Tollroad Control Centre Traffic Design Elements

TC-2113-SR-00-0001_0

LEGACY WAY

1. Car Park Review

PROJECT:
 NEW TUNNEL CONTROL CENTRE
 O'CONNELL
 TERRACE BOWEN HILLS OPTION C
 Drawing Title:
 GROUND FLOOR GENERAL ARRANGEMENT
 FLOOR PLAN

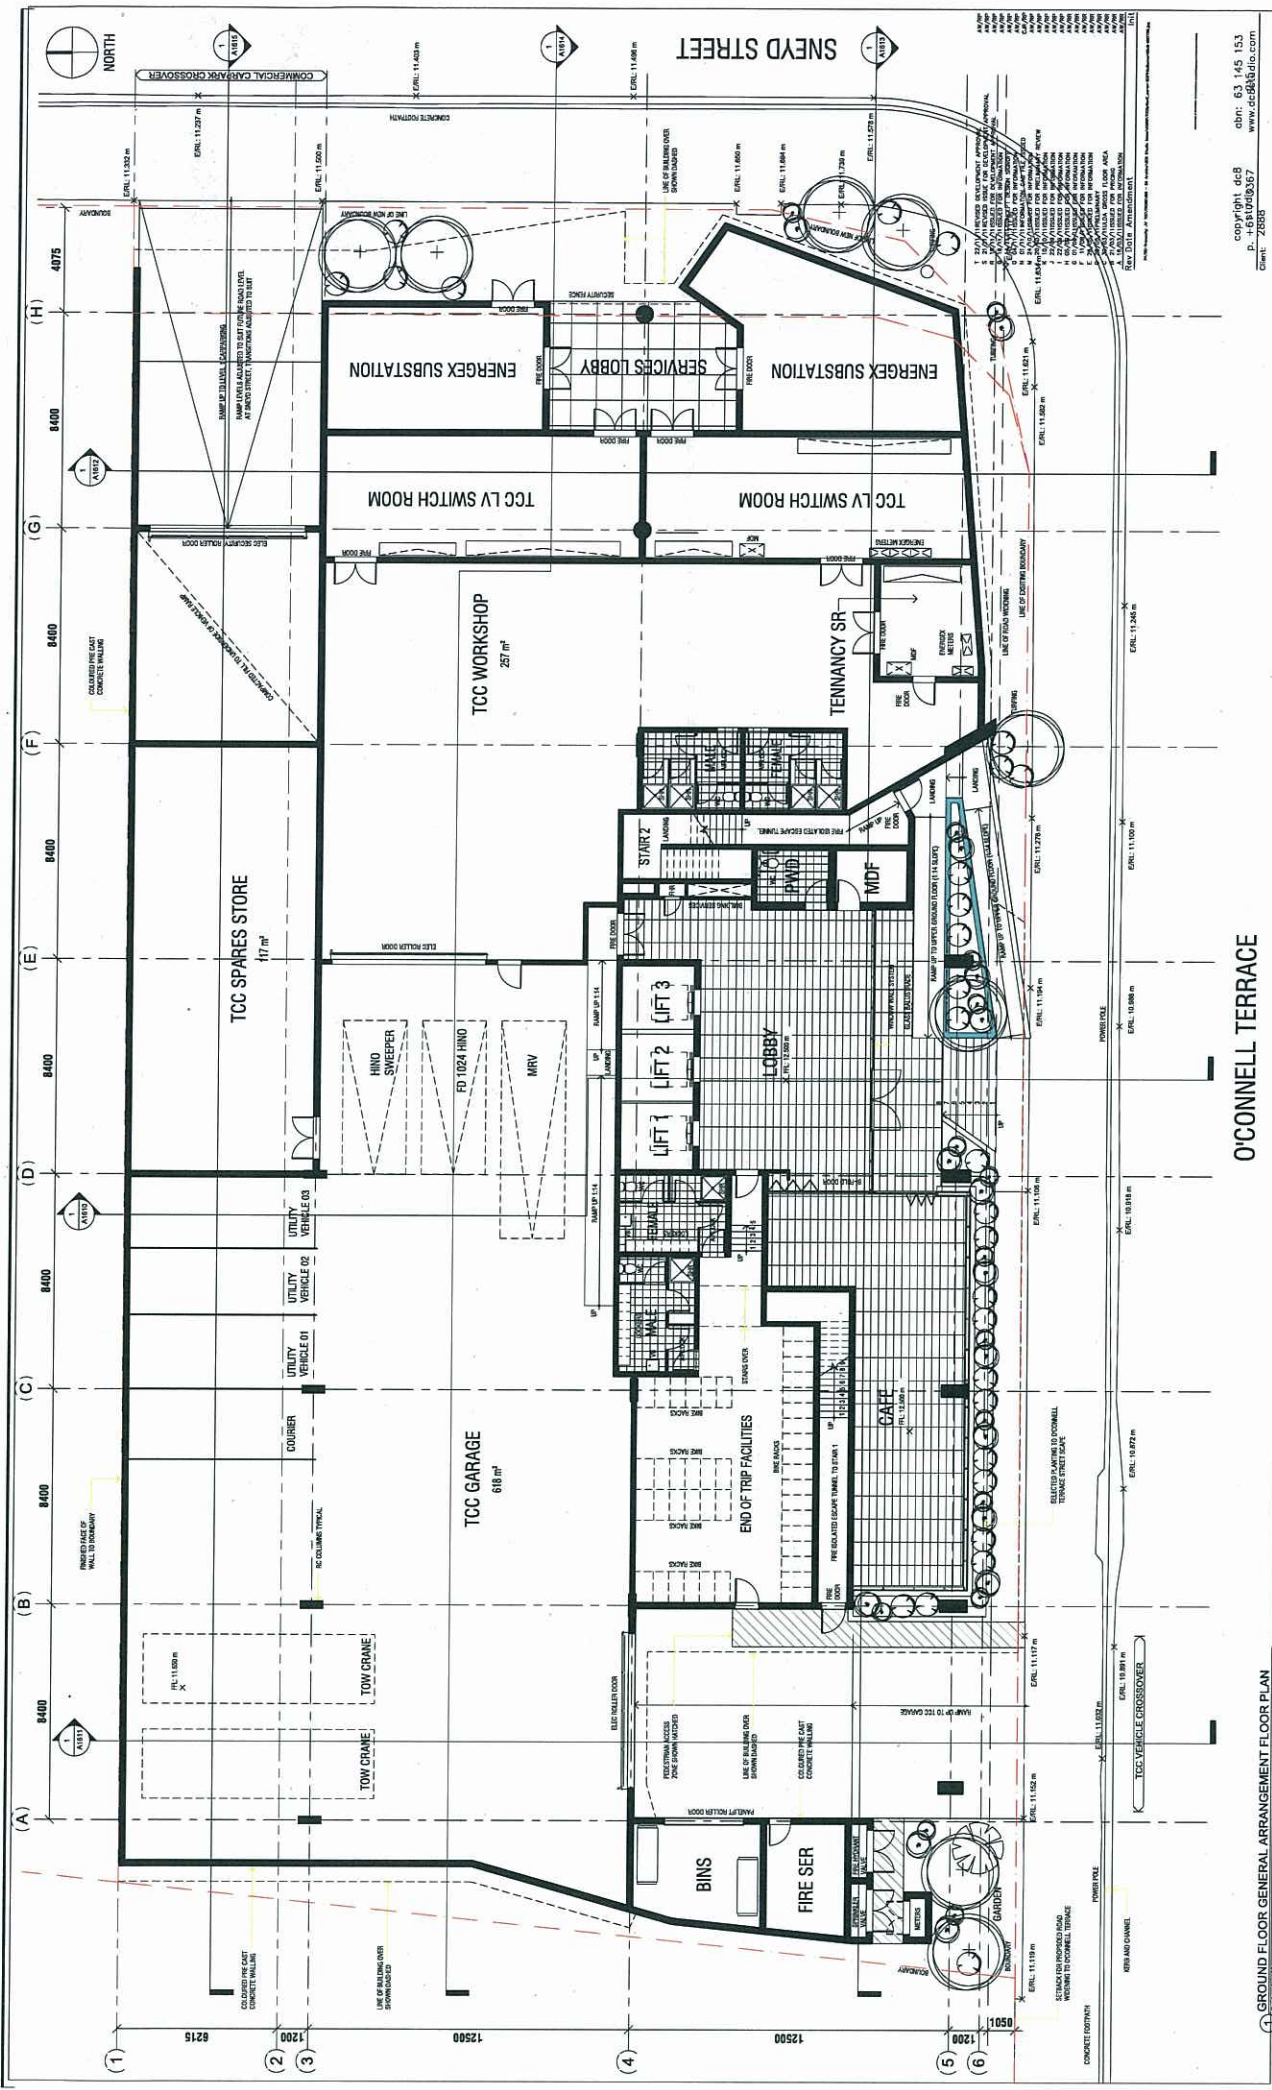
Based on the proposed land uses, the maximum service vehicle required would be a Rubbish Collection Vehicle (RCV). Under BCC guidelines, an RCV needs a minimum vertical clearance of 6.1m to enable collection bins to be emptied overhead. An appropriate area for the RCV to empty collection bins is located adjacent to the bin enclosure in the entrance way to the Transcity garage on O'Connell Terrace. The vertical clearance in this area well exceeds the 6.1m minimum requirement. The RCV will be able to proceed into the garage to turn around and leave the site in a forward direction, as is required.

BCC's Transport, Access, Parking and Servicing Planning Scheme Policy (TAPS) requires a Medium Rigid Vehicle (MRV) to service the retail and office components. An appropriate parking space for an MRV is provided in the Transcity garage with good accessibility to the lifts.

It is noted that the new arrangement allows acceptable access to all the vehicles required to use the Transcity garage.

Drawing Title:
**LEVEL 1 GENERAL ARRANGEMENT FLOOR
PLAN**

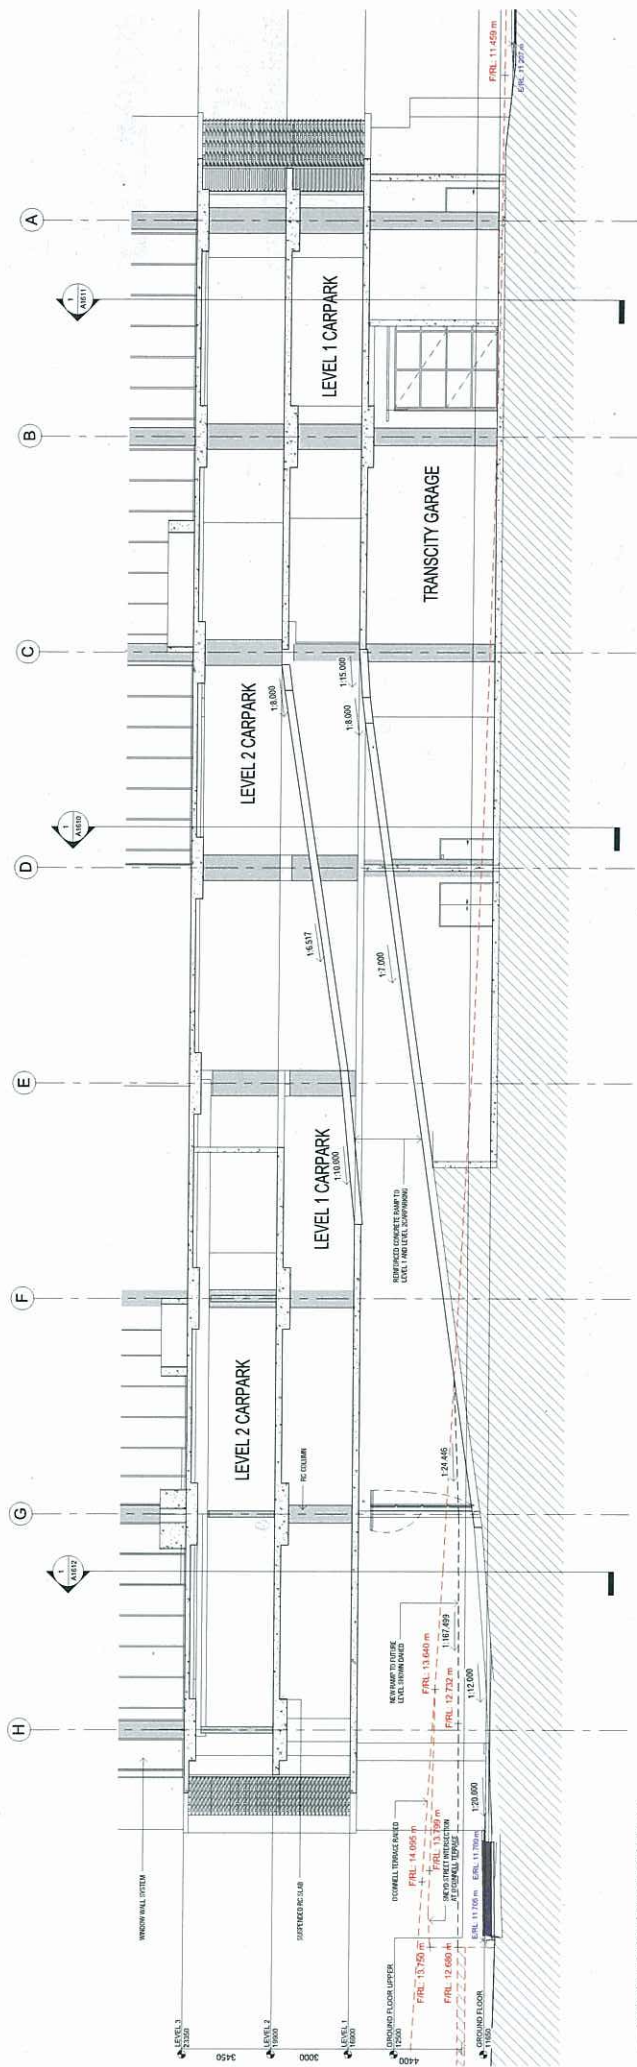
TAPS indicates that there needs to be 1 disabled space per 4,500sq.m for an office. This would require 2 disabled parking spaces for office uses, which is the number of spaces provided on Level 1. The code also indicates that there needs to be 1 disabled parking space per 300sq.m of retail, which is the number of spaces provided on Level 2.

There is significant use of tandem spaces in the Level 1 and Level 2 parking areas. It is noted that while the number of tandem bays is not specifically limited, there is a requirement that tandem bays must both be assigned to the same business, which would be the case.

Swept path analysis has been undertaken to identify if two vehicles are able to pass each other at the turns (involving a 99th percentile and 85th percentile vehicle). The analysis shows that this is not possible without impeding into a number of tandem bays, as well as a column.

It is recommended that mirrors be installed to allow vehicles to view around the hazardous corners. As vehicle entry and exit is usually tidal, this approach is deemed adequate to address the limited number of occasions when opposing vehicles would meet.
